**NEW YORK STATE THRUWAY AUTHORITY  
DEPARTMENT OF ENGINEERING**

**AMENDMENT NO. 1  
TO**

**CONTRACT TAA 24-6B  
D214960  
SCOUR REPAIRS AT VARIOUS BRIDGES,  
MP 165.10, MP 171.31, MP 174.71, MP 179.76, AND MP 185.93  
IN THE ALBANY DIVISION  
OF THE NEW YORK STATE THRUWAY  
IN SCHENECTADY AND MONTGOMERY COUNTIES**

**IN THE LETTING OF  
JANUARY 10, 2024**

TITLE OF PROJECT: SCOUR REPAIR AT VARIOUS BRIDGES  
CONTRACT NUMBER: TAA 24-6B  
LOCATION OF PROJECT: MP 165.10 TO MP 185.93  
DATE: NOV 2023  
TITLE OF DRAWING: MP 165.10 I-90 OVER RESERVOIR ROAD & CREEK EXISTING PLAN  
DRAWING NUMBER: ST1-04

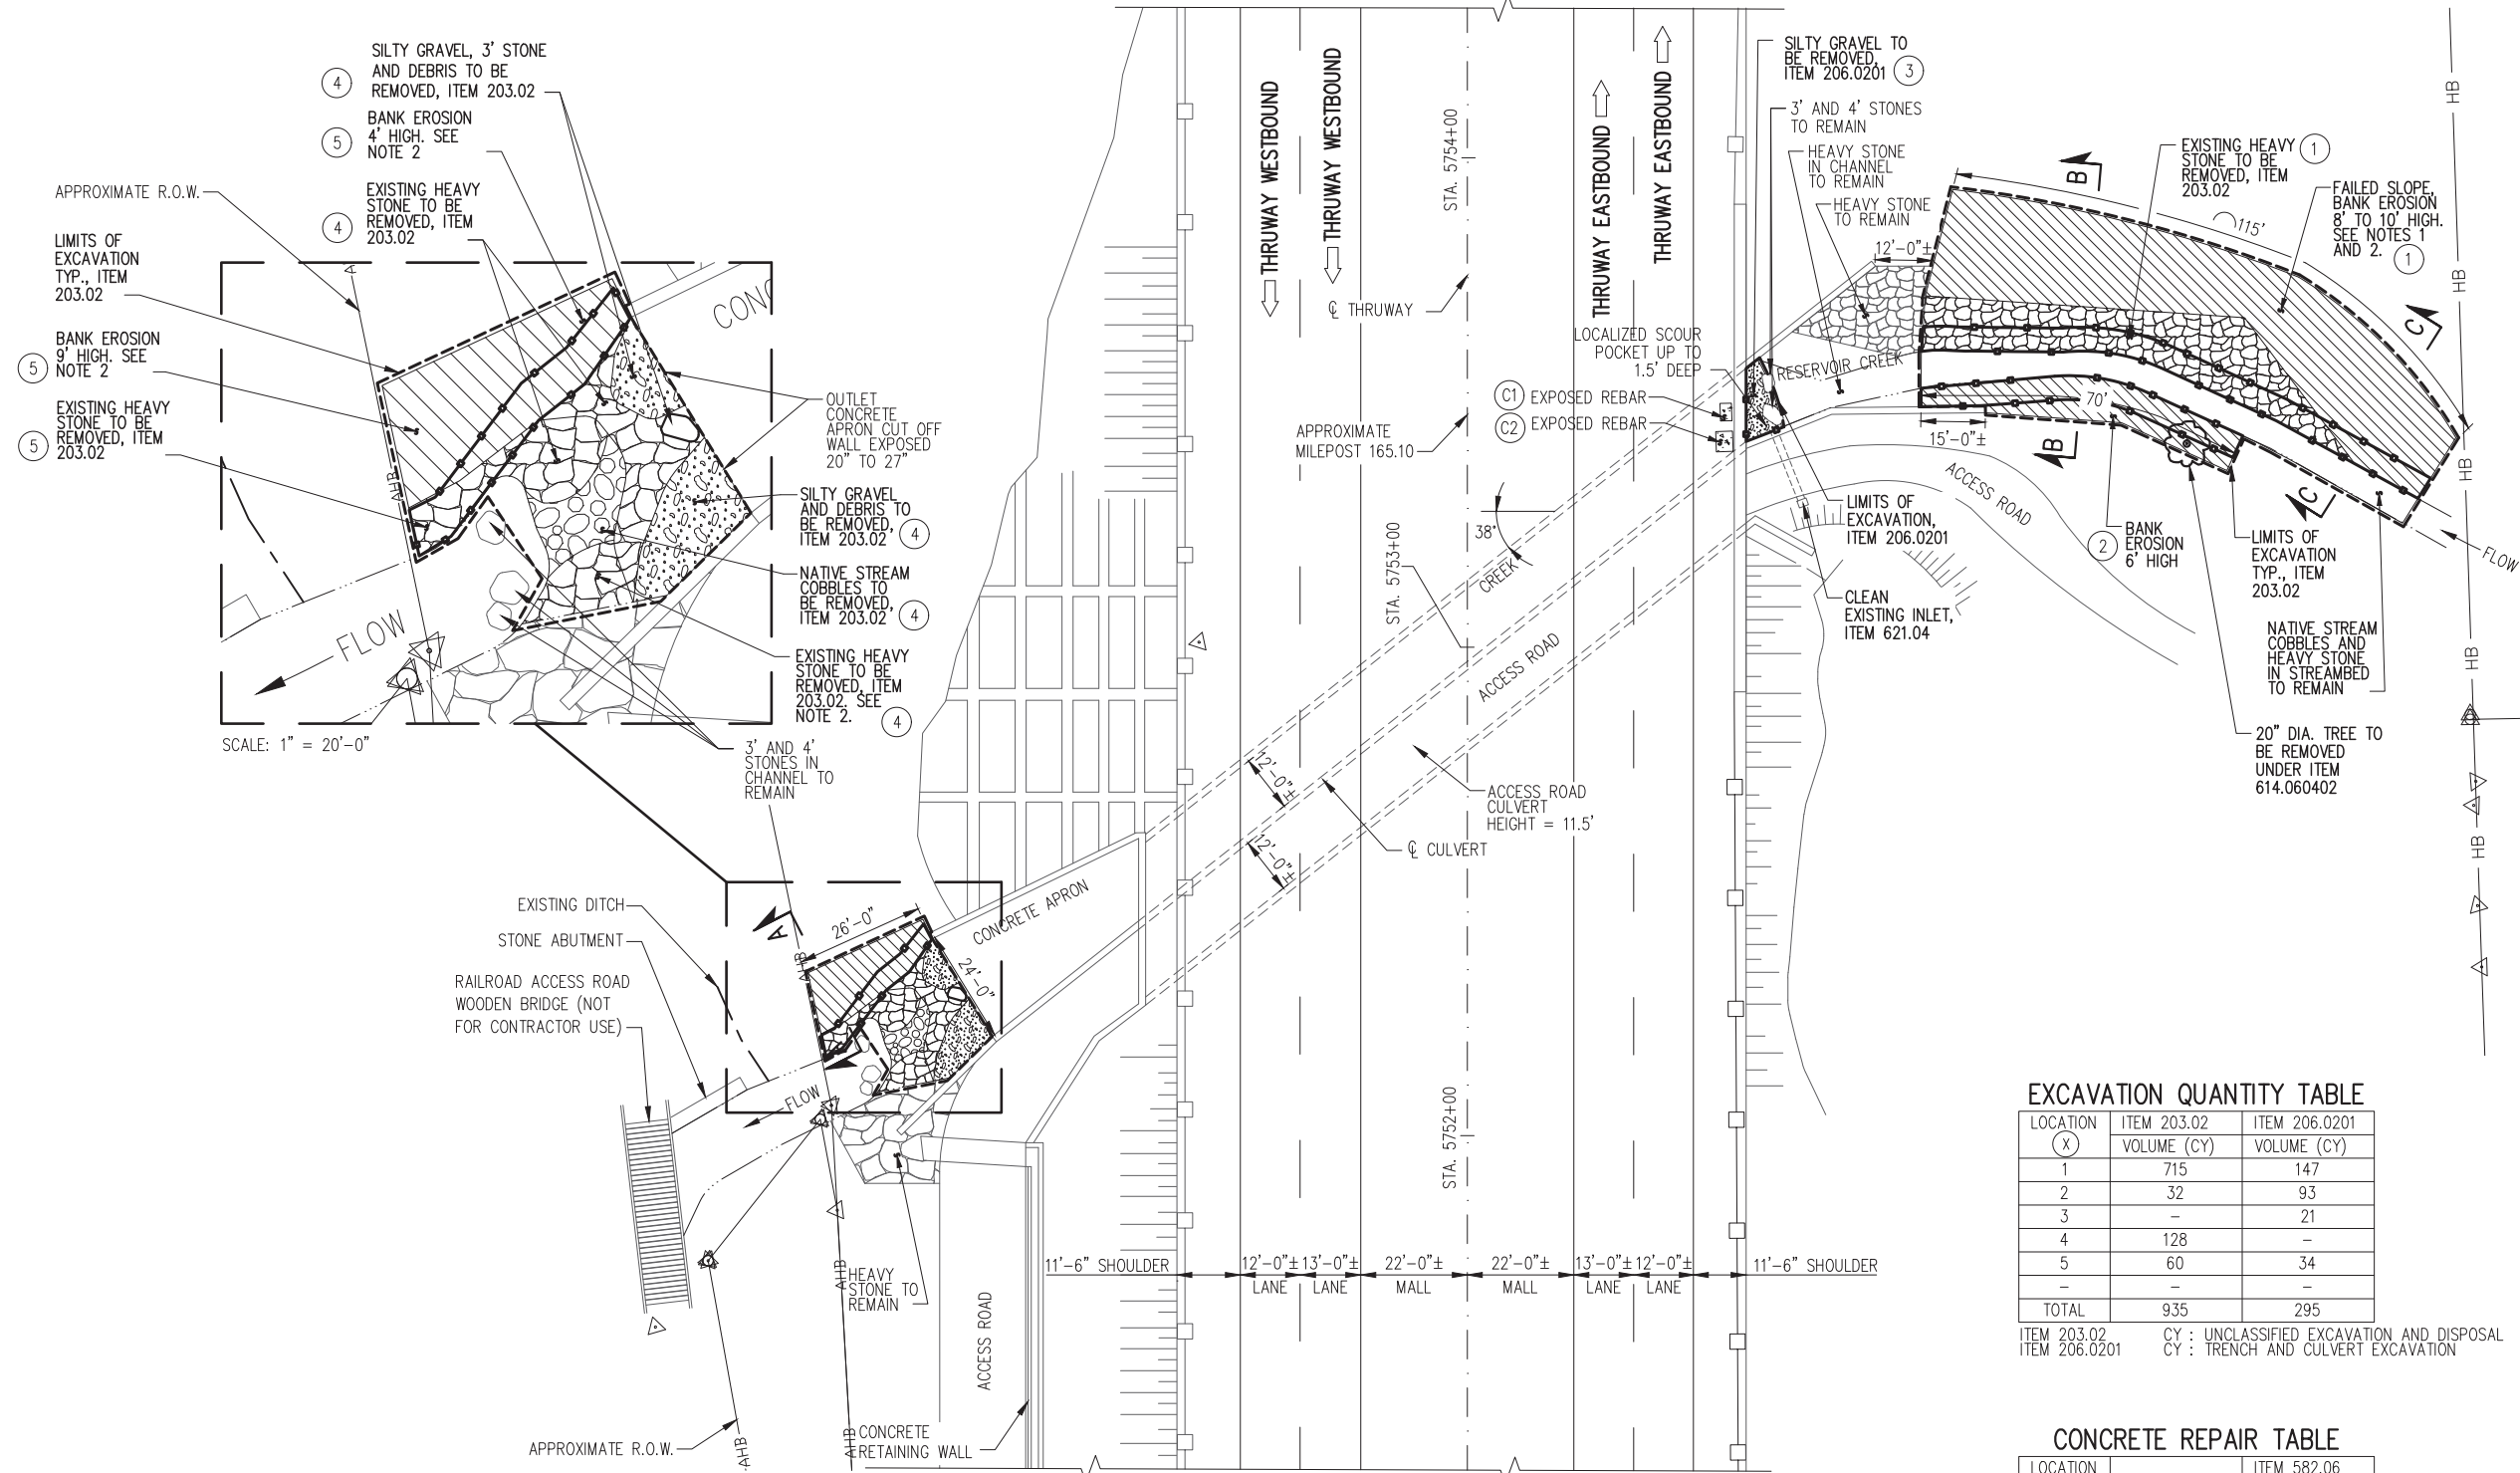
4. **DELETE** Drawing Number ST1-04, Sheet 11 of 31 and **REPLACE** with the attached new Drawing Number ST1-04-A1, Sheet 11-A1 of 31.
  - Revised work limits so excavation is outside of streambed.

- Revised numbering of work locations.
  - Revised quantities of excavation and trench and culvert excavation.
5. **DELETE** Drawing Number ST1-05, Sheet 12 of 31 and **REPLACE** with the attached new Drawing Number ST1-05-A1, Sheet 12-A1 of 31.

TITLE OF PROJECT SCOUR REPAIR AT VARIOUS BRIDGES	CONTRACT NUMBER: TAA 24-6B
LOCATION OF PROJECT MP 165.10 TO MP 185.93	DATE: NOV 2023
TITLE OF DRAWING MP 165.10 I-90 OVER RESERVOIR ROAD & CREEK PROPOSED PLAN	DRAWING NUMBER: ST1-05

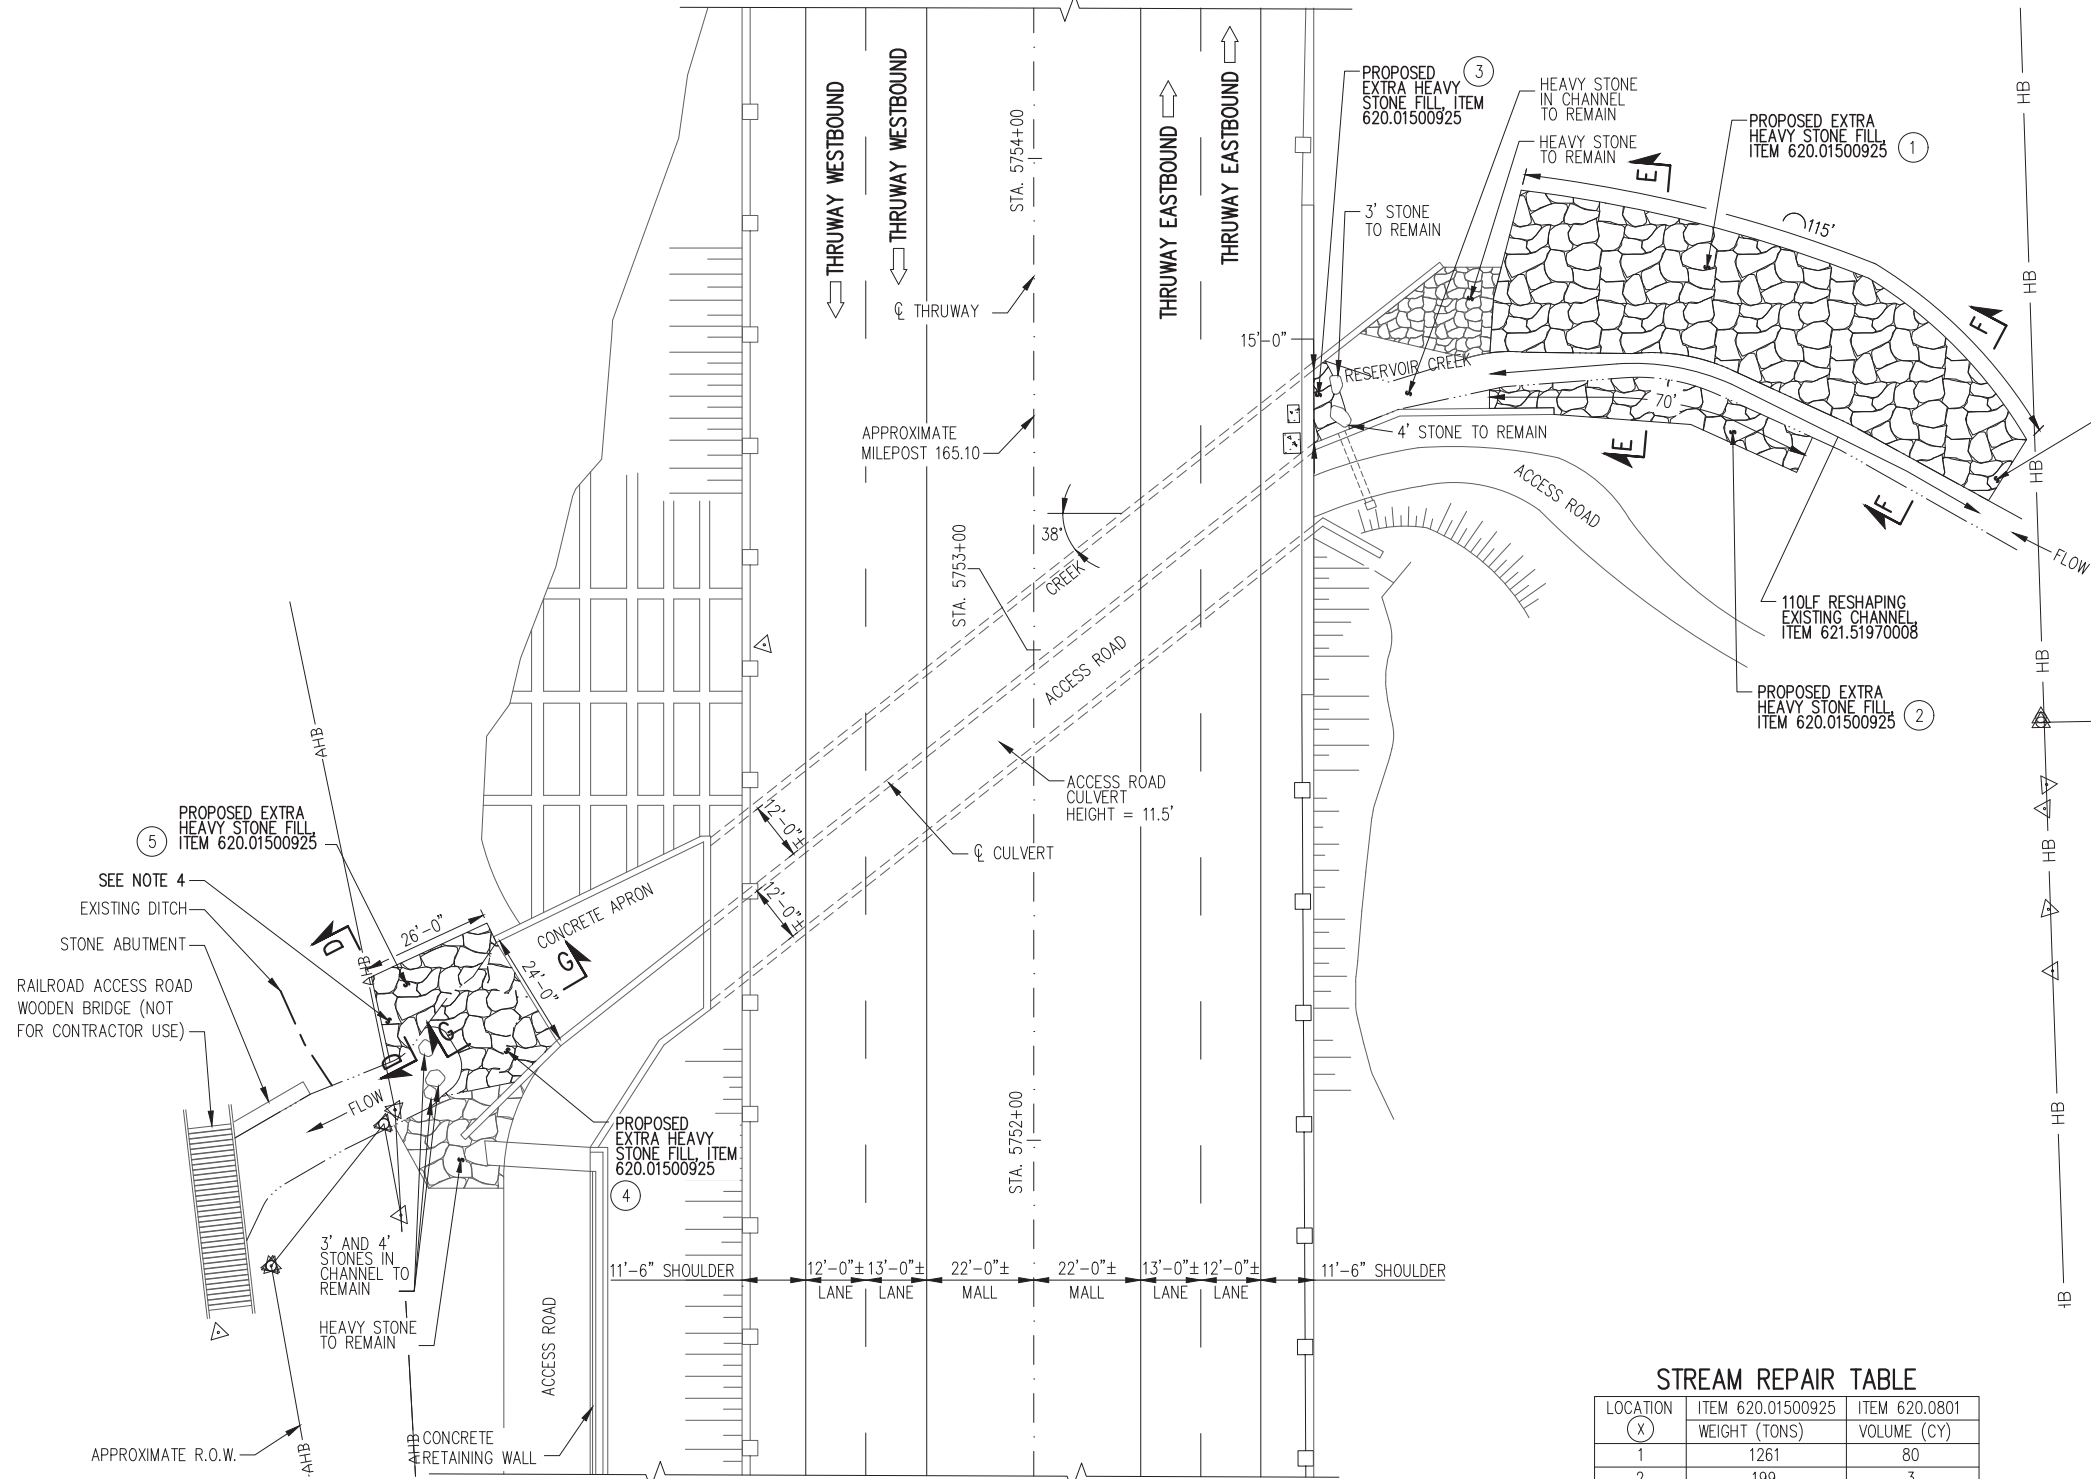
- Revised work limits to indicate no new stone in streambed.
  - Revised numbering of work locations.
  - Revised quantities of heavy stone and bedding material.

TITLE OF PROJECT SCOUR REPAIR AT VARIOUS BRIDGES	CONTRACT NUMBER: TAA 24-6B
LOCATION OF PROJECT MP 165.10 TO MP 185.93	DATE: NOV 2023
TITLE OF DRAWING MP 165.10 I-90 OVER RESERVOIR ROAD & CREEK SITE SPECIFIC DETAILS	DRAWING NUMBER: ST1-06

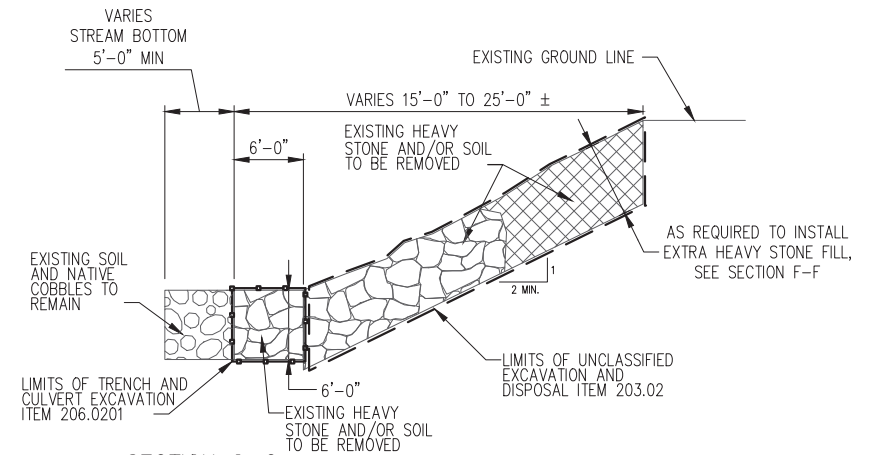
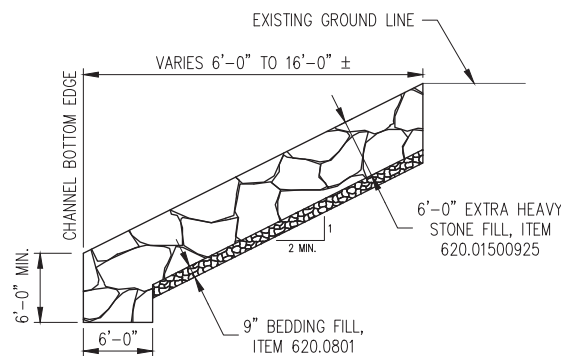
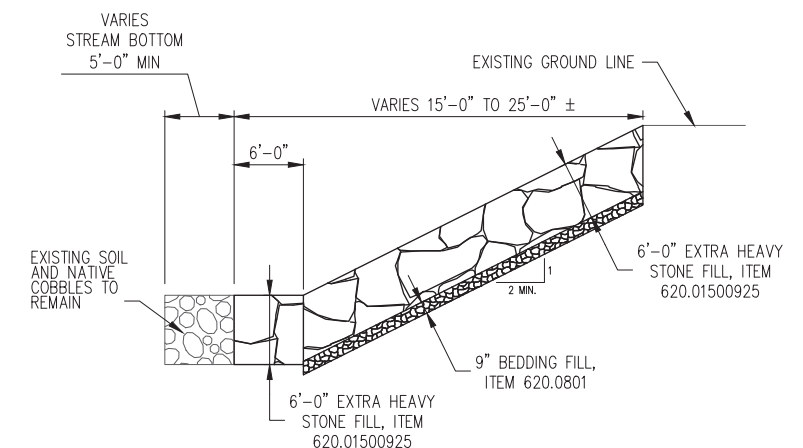
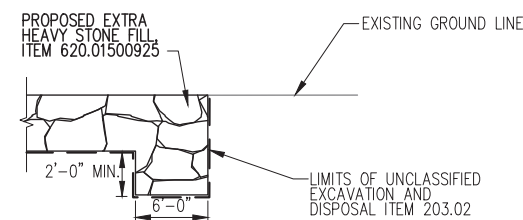
6. **DELETE** Drawing Number ST1-06, Sheet 13 of 31 and **REPLACE** with the attached new Drawing Number ST1-06-A1, Sheet 13-A1 of 31.
  - Revised sections B-B, C-C, E-E and F-F to indicate existing soil and native cobbles in streambed are to remain.

<b>Thruway Authority</b>	TITLE OF PROJECT SCOUR REPAIR AT VARIOUS BRIDGES	CONTRACT NUMBER: TAA 24-6B
	LOCATION OF PROJECT MP 165.10 TO MP 185.93	DATE: NOV. 2023
	TITLE OF DRAWING TYPICAL DETAILS	DRAWING NUMBER: SD-01

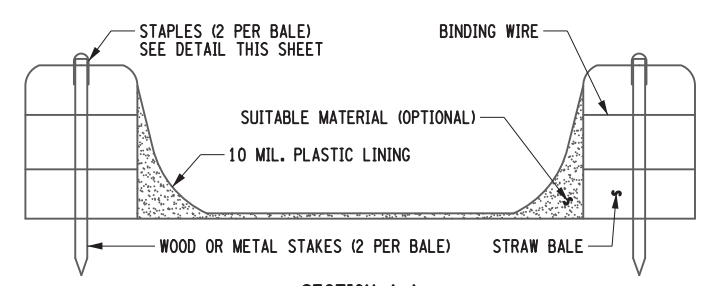
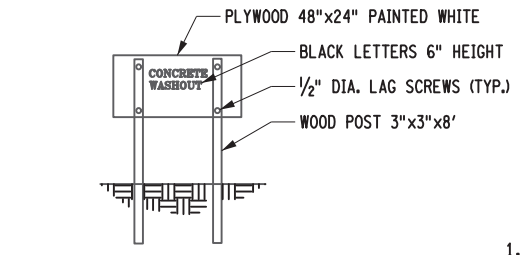
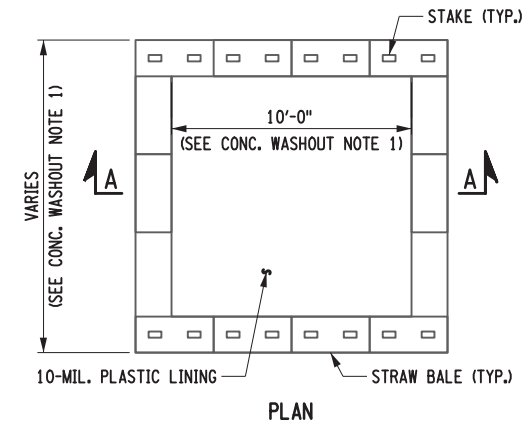
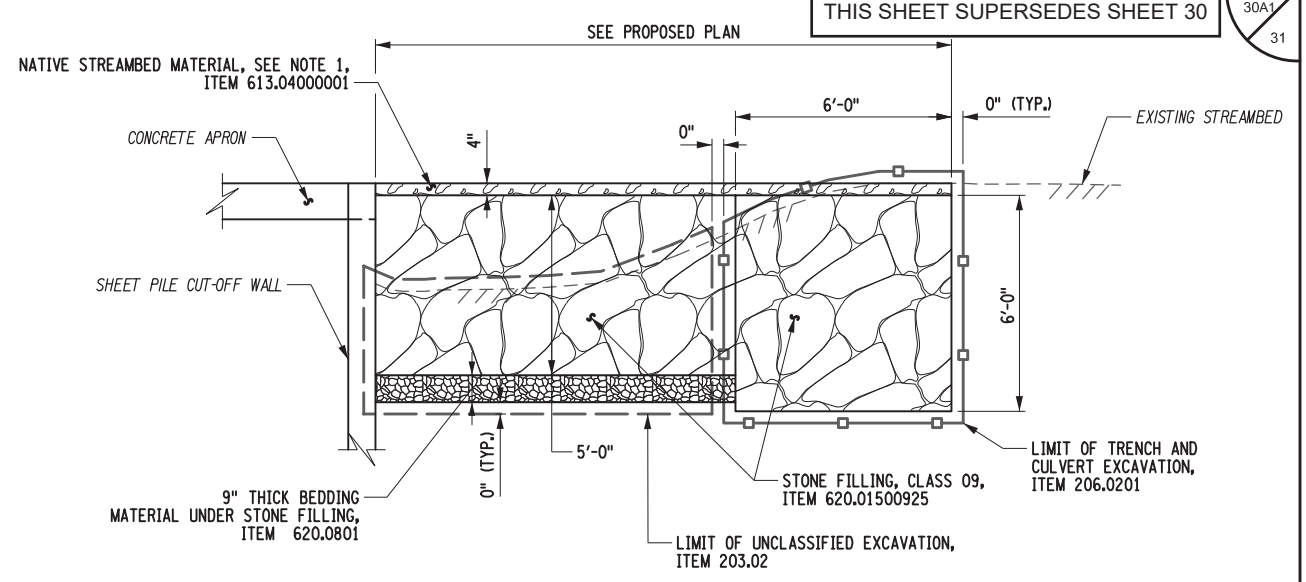
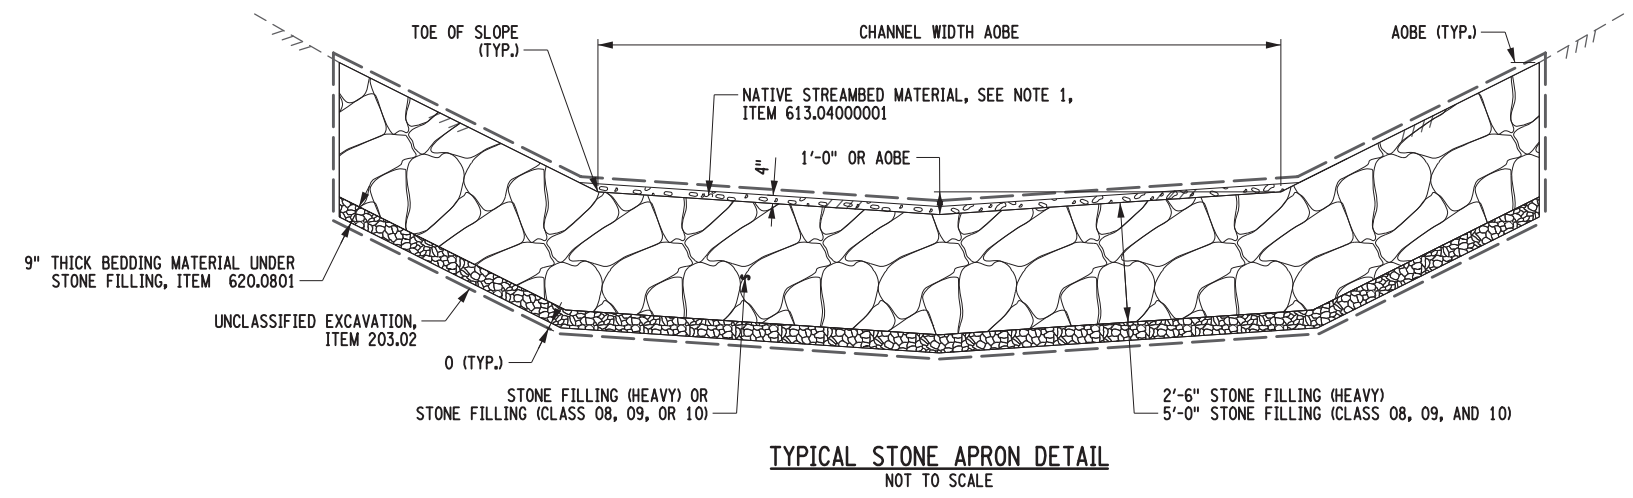
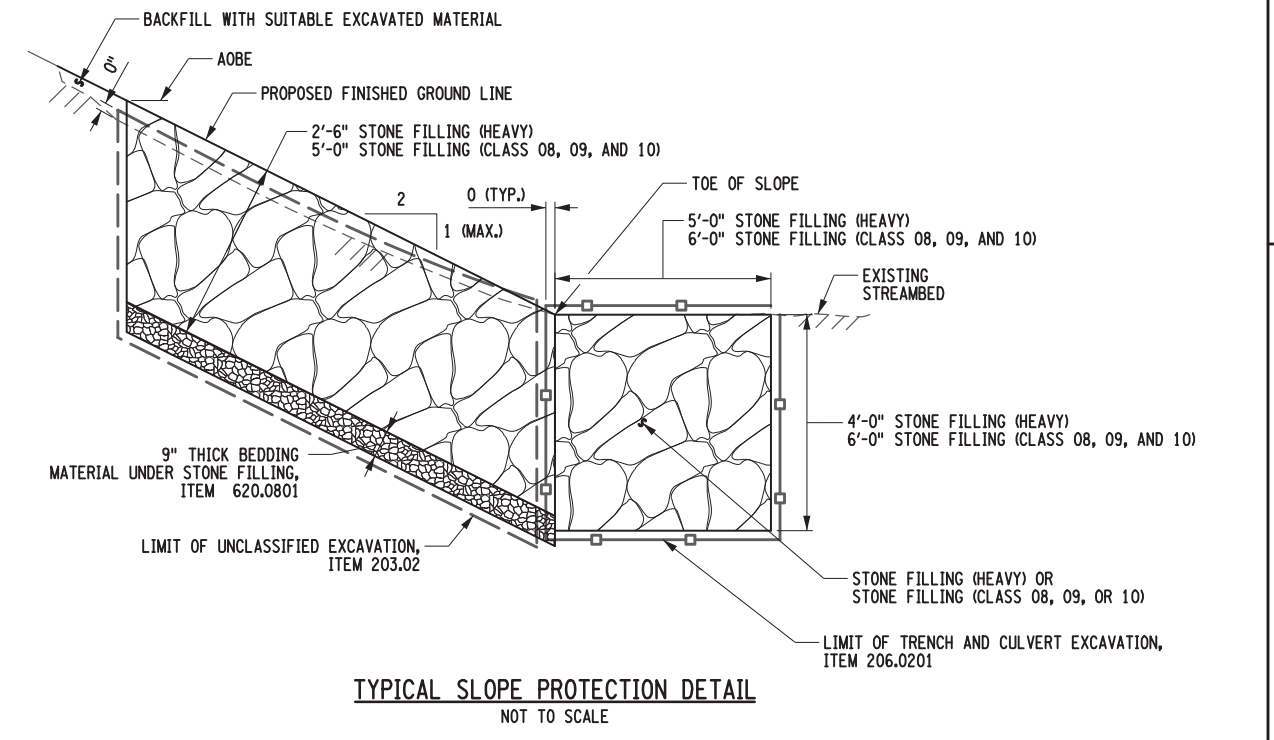
11. **REVISE** Drawing Number ST4-03, Sheet 26 of 31 by replacing the reference to “VOLUME (CY)” in the Stream Repair Table under Item 620.0150XX25 with “WEIGHT (TON)”, instead.
12. **DELETE** Drawing Number SD-01, Sheet 30 of 31 and **REPLACE** with the attached new Drawing Number SD-01-A1, Sheet 30-A1 of 31.
  - Added concrete washout details and notes, and
  - Revised the Title of Drawing from “STREAM PROTECTION DETAILS” to “TYPICAL DETAILS”.
